City of Portsmouth
Department of Public Works

Bid Proposal #30-06
Shoreline Repairs Prescott Park and Four Tree Island
Addendum #1
January 27, 2006

PRESCOTT PARK SECTIONS

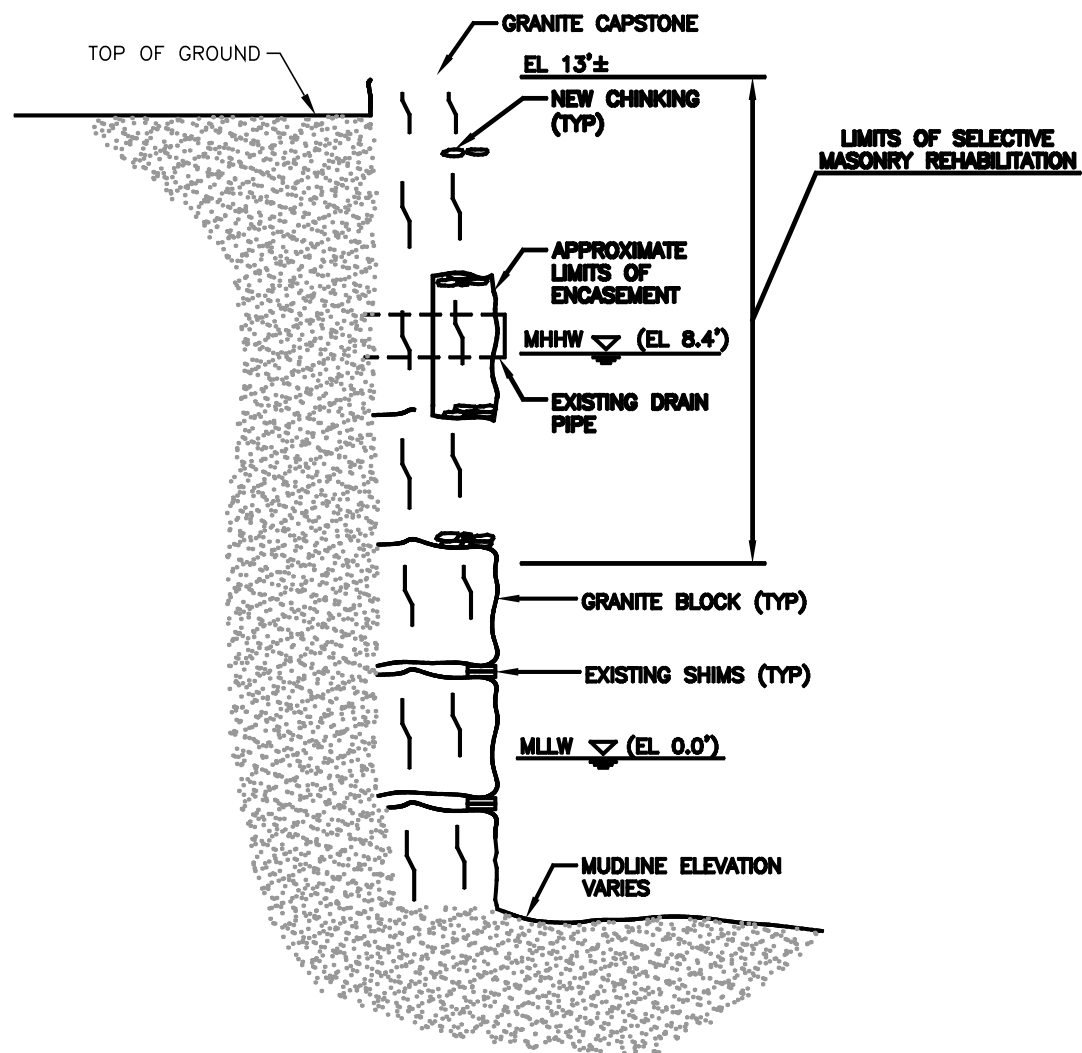
Alternate #1 Drain Line Modifications:

There is an old drain line extending into the river between T-Head Pier and the Existing Pier. This pipe consists of small sections of 30" Cast Iron pipe and is essentially lying on the river bottom. The proposed modifications consist of the following:

1. Excavate old 30" CI drain pipe from where it exits the ground at approximately mid-tide level to its termination near the end of the existing pier. (Approximately 100 LF)
2. This new termination shall be slip-lined with a 27" PVC pipe and mortared in place for a minimum length of 10'. Contractor to confirm the pipe size.
3. Rip Rap Class A shall be placed around the new out-fall to stabilize the structure in accordance with the Standard Details Sheet 2 of 3 entitled Prescott Park Sections.
